Wisconsin Department of Transportation

Proposal #06: 1100-20-70, WISC 2025004
IH 41 Zoo Freeway
Burleigh St to Capitol Dr
IH 41
Milwaukee County

1100-20-71, WISC 2025005 IH
41 Zoo Freeway
Capitol Dr to Silver Springs Dr
IH 41
Milwaukee County

This is Addendum No. 02, which provides for the following:

Addendum No. 02
ID 1100-20-70
Revised Sheet 2
September 26, 2024

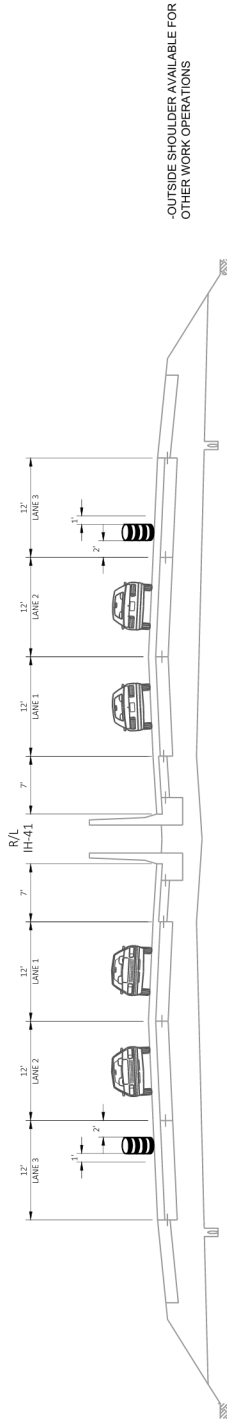
Revised Plan Sheets	
Plan Sheet	Plan Sheet Title (brief description of changes to sheet)
	ID 1100-20-70
2	Pavement type and layer thickness table corrected for ID 1100-20-70
399	Items 643.0500 & 643.0600 added to MQs
401	Location added and quantities added to MQs for items 643.0420, 643.0705, & 643.0900
403	Item 646.1020 added to MQs
432-437	Corrected PWL Table
	ID 1100-20-71
79	New work called out in plan details near B-40-217 & B-40-216
80	New work called out in plan details near B-40-217 & B-40-216
130	Revised storm sewer plan sheet
408	Item quantity updated for 204.0157
410	Item 511.1100 added to MQs
411	Locations and quantities added to MQs for items 603.1442, 603.3213 & 603.3535
412	Additional locations and quantities on pg 1321 caused rows to move on pg 1322
413	Quantity changes for items 603.1442, 603.3213 & 603.3535
425	Revised storm sewer MQs
428	Revised storm sewer MQs
429	Revised storm sewer MQs

Addendum No. 02
ID 1100-20-70
Added Sheet 25A
September 26, 2024

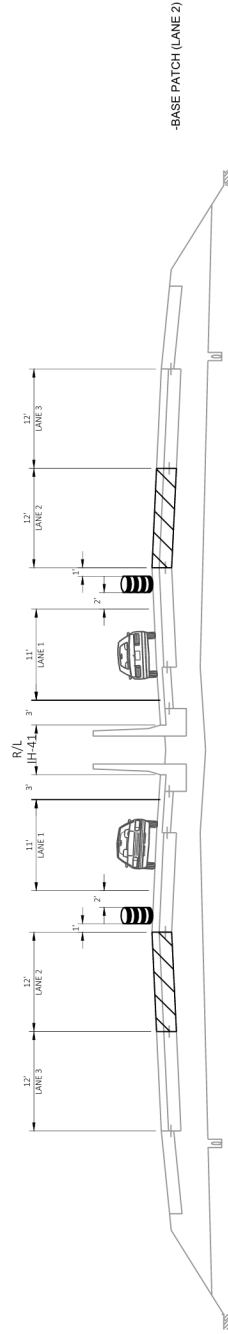
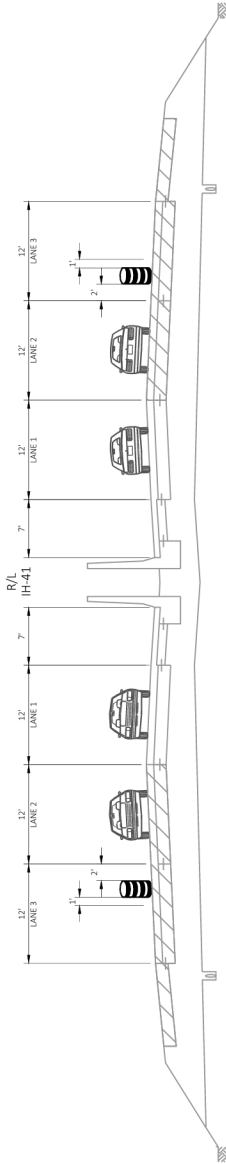
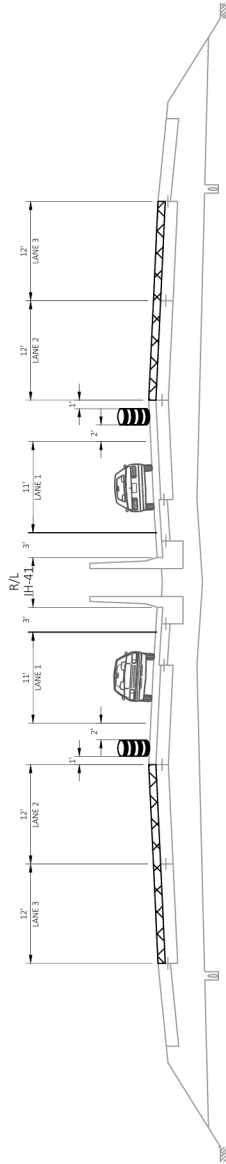
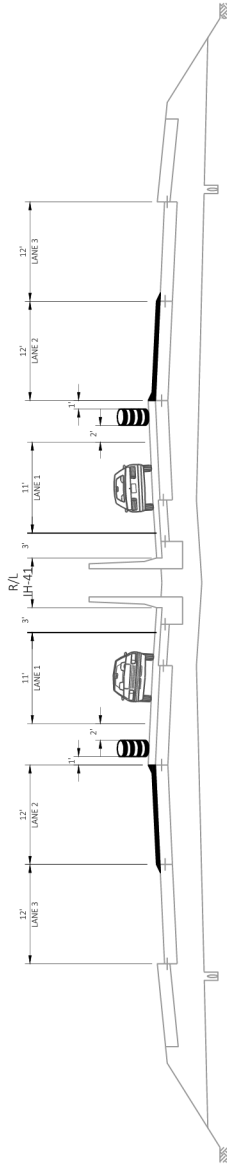
Added Plan Sheets	
Plan Sheet	Plan Sheet Title (brief description of why sheet was added)
	ID 1100-20-70
25A	Construction Details (Lane 2 Paving Sequence) 1/4 - Clarify paving sequence for lane 2
25B	Construction Details (Lane 2 Paving Sequence) 2/4
25C	Construction Details (Lane 2 Paving Sequence) 3/4
25D	Construction Details (Lane 2 Paving Sequence) 4/4
366A	Burleigh St Median Closure (Mayfair Rd/ HWY 100) – TMP agreement requirement
	1100-20-71
581A	SDD 14B36-02c – Omitted in original submission

Addendum No. 02
ID 1100-20-71
Revised Sheet 465
September 26, 2024

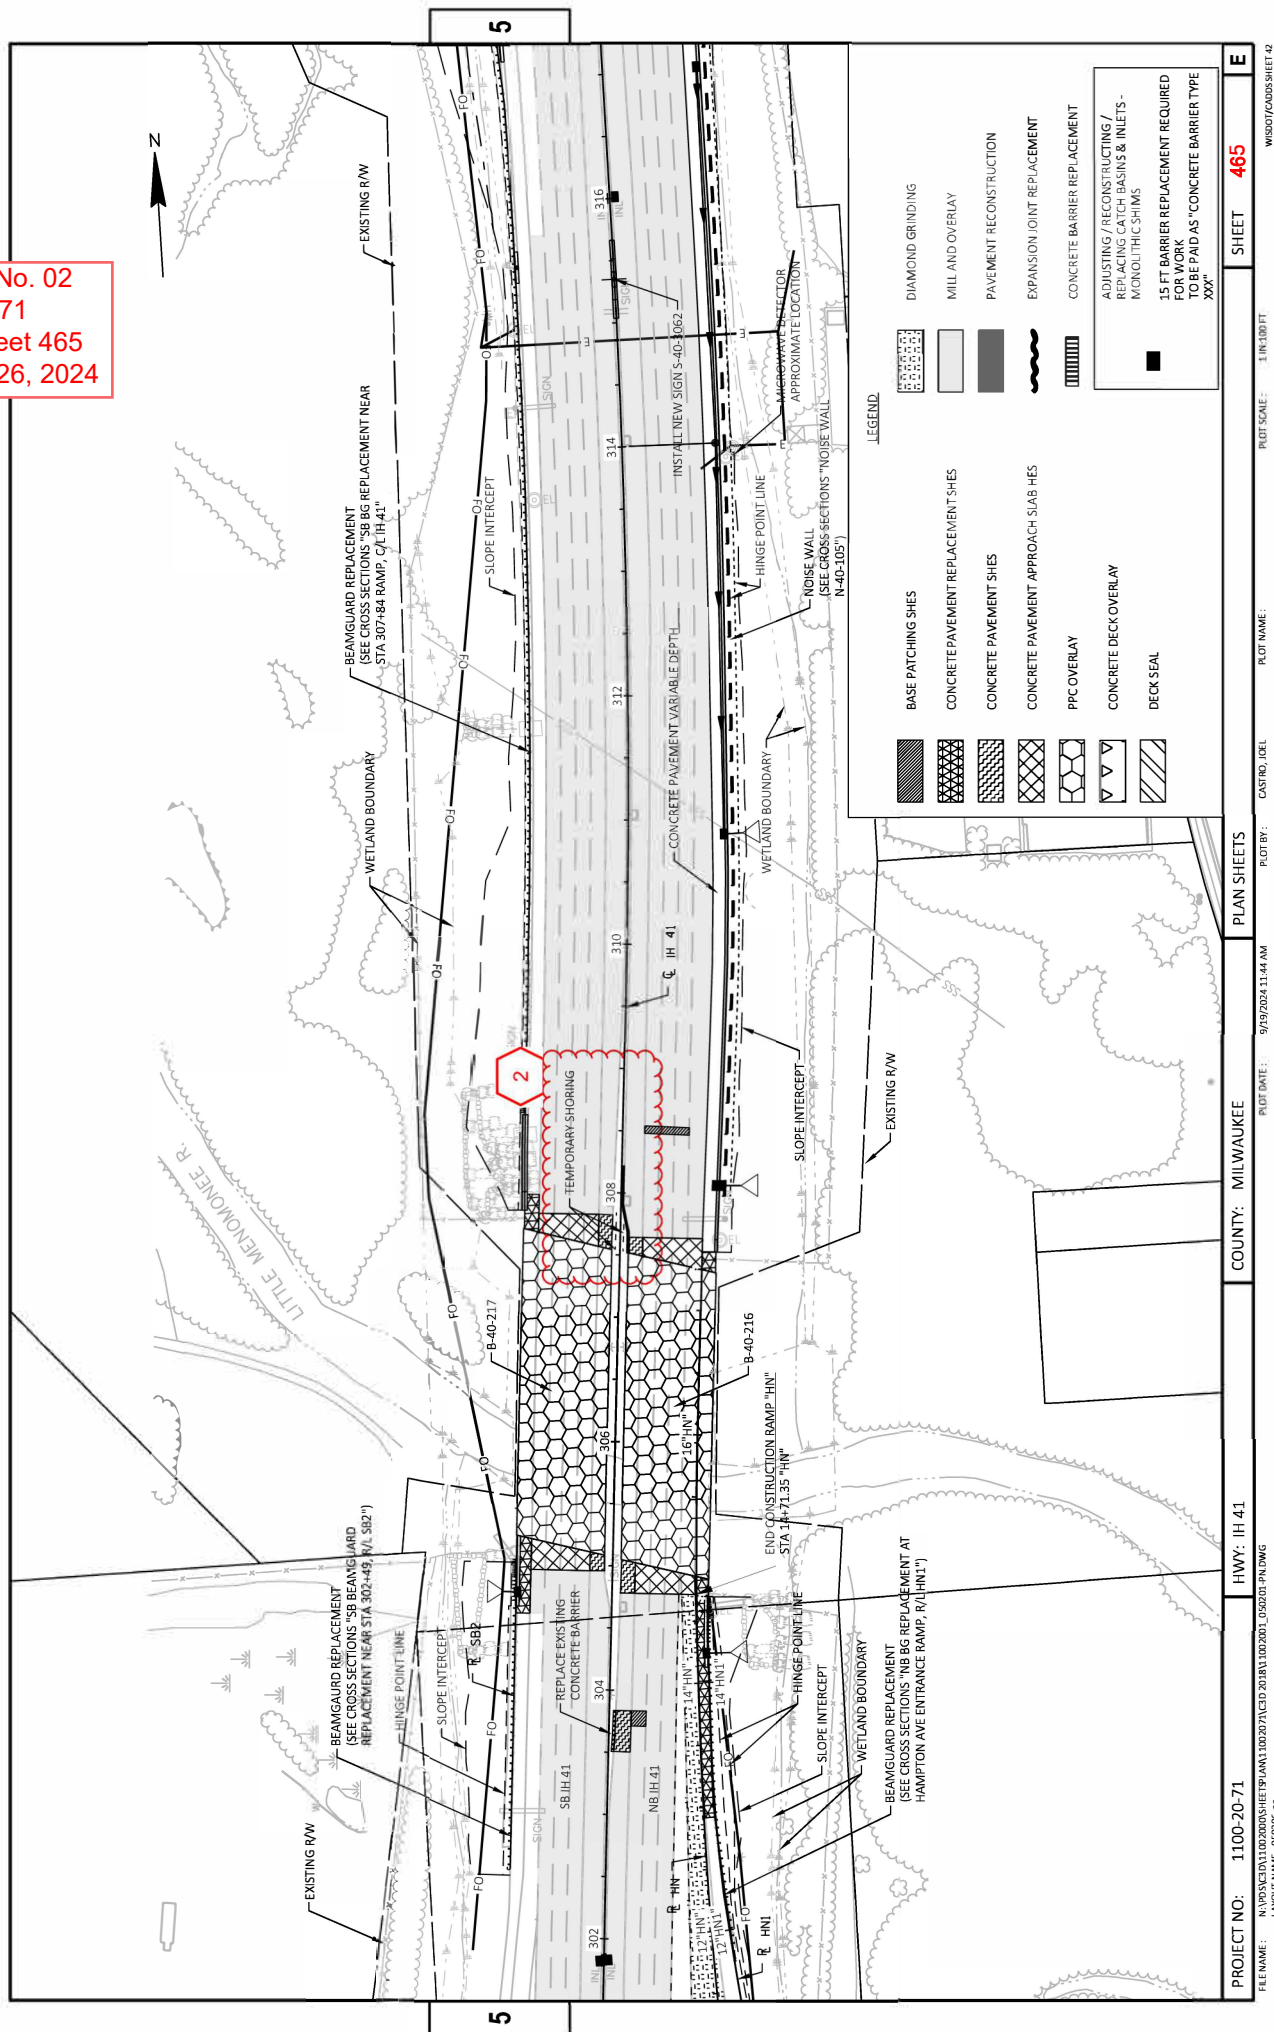
430	Revised storm sewer MQs
431	Revised storm sewer MQs
465	New work called out in plan sheets: "temporary shoring" & and concrete barrier replacement limits updated
